City of San Antonio

Re: Creamer Subdivision

MDP # 772-A

CREAMER SUBDIVISION
 PRELIMINARY OVERALL AREA DEVELOPMENT PLAN
 AMENDMENT A - PLAN NO. 772-A

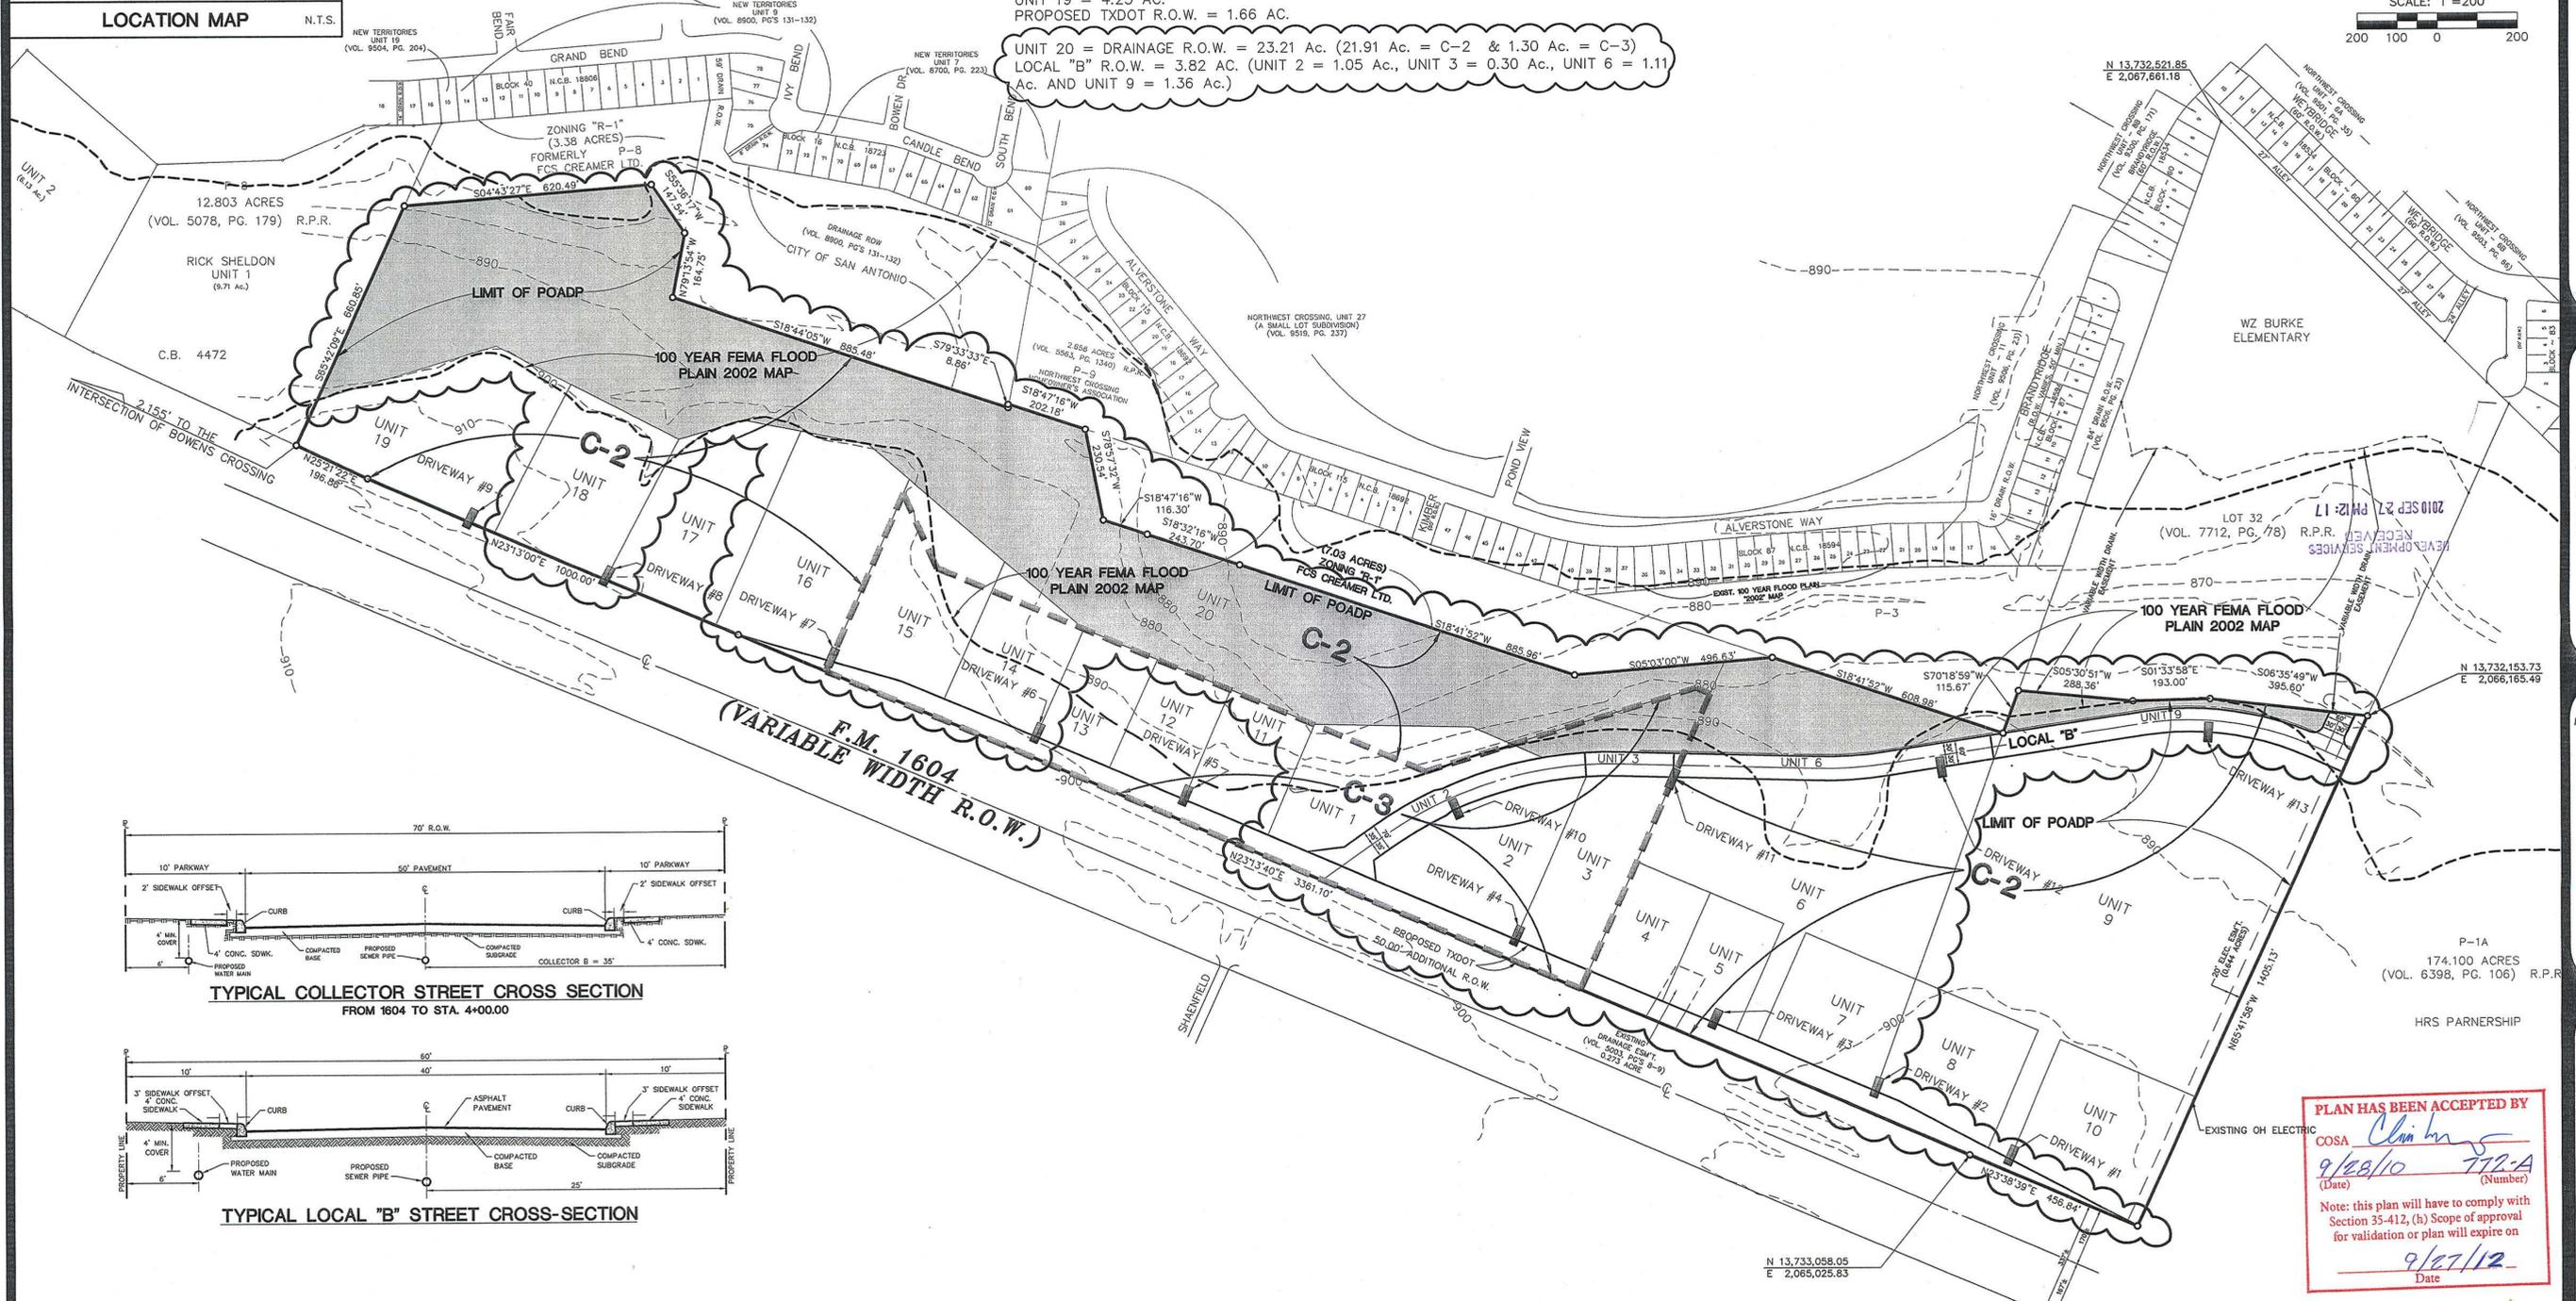
PDS Traffic Impact Analysis & Streets approves with the following conditions:

- **Northbound Loop 1604** – Right turn deceleration lanes with storage and bay taper as it relates to the submitted TIA traffic counts, UDC - 35-502 (a)(7), subsection C are required at driveway locations No. 1 thru No. 9.

- **Shaenfield Road** – Provide left and right turn deceleration lanes with storage and bay taper as it relates to the submitted TIA traffic counts (UDC – 35-502 (a)(7), subsection C) along Shaenfield Rd at the following intersections:

- Driveway No. 10 (eastbound and westbound)
 - Driveway No. 12 (eastbound right, westbound left)
 - Driveway No. 13 (eastbound right, westbound left)
- **Shaenfield Road at Driveway No. 11** – Right turn deceleration lane with storage and bay taper as it relates to the submitted TIA traffic counts, UDC - 35-502 (a)(7), subsection C.

- **Intersection of Northbound Loop 1604 and Westbound Shaenfield extension** - Provide left and right turn deceleration lanes with storage and bay taper as it relates to the submitted TIA traffic counts (UDC – 35-502 (a)(7), subsection C).

- Shaenfield Road extension shall be a collector roadway up to driveway no.10
- Coordinate with TXDOT and City of San Antonio Public Works Department for the improvements to the signal at the intersection of Loop 1604 & Shaenfield Road.

- No bicycle lane required due to lack of connectivity to adjacent roadways.
- Driveway throat lengths for all driveways shall comply with City of San Antonio UDC 35-506, Table 506-7 requirements, to facilitate the safe and efficient flow of traffic.

- All access driveways shall comply with UDC 35-506 (r) (8) Alignment.
- Coordinate with TXDOT for mitigation improvements along state maintained roadways.
